Please share your comments on the proposed Rochester Natural Gas Pipeline Project

April 4 - 2016

Proposed Town Border Station & Route Buffer

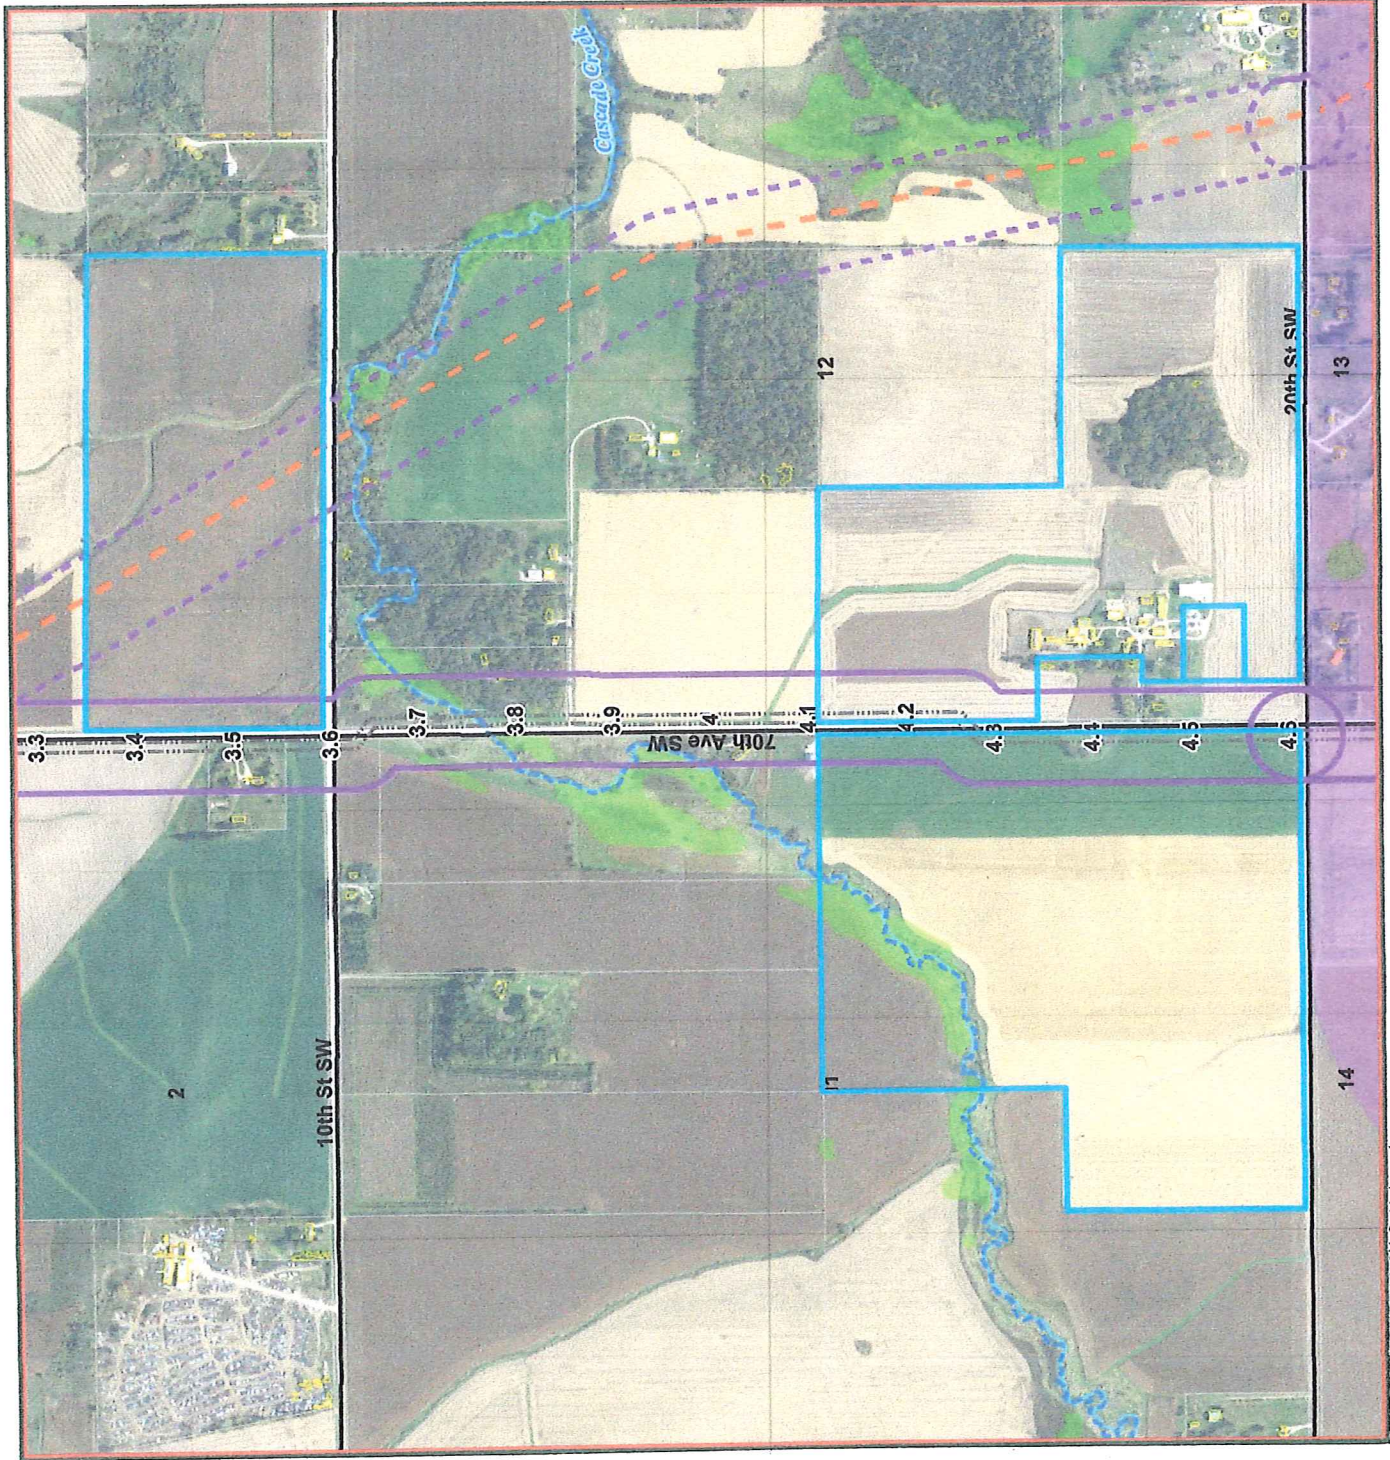
We are 100 percent against the Preferred Route for the Rochester Natural Gas Pipeline Project. It will not work for us at all. We have four farm tile lines crossing the road. We have header tile lines running parallel with the road. We all so have tile lines placed every 90 feet for the entire 1/2 mile of road. These tile lines have been in for over 50 years with no problems.

We will try to work with the alternate route. We prefer the west side of the alternate route. Along Pipeline
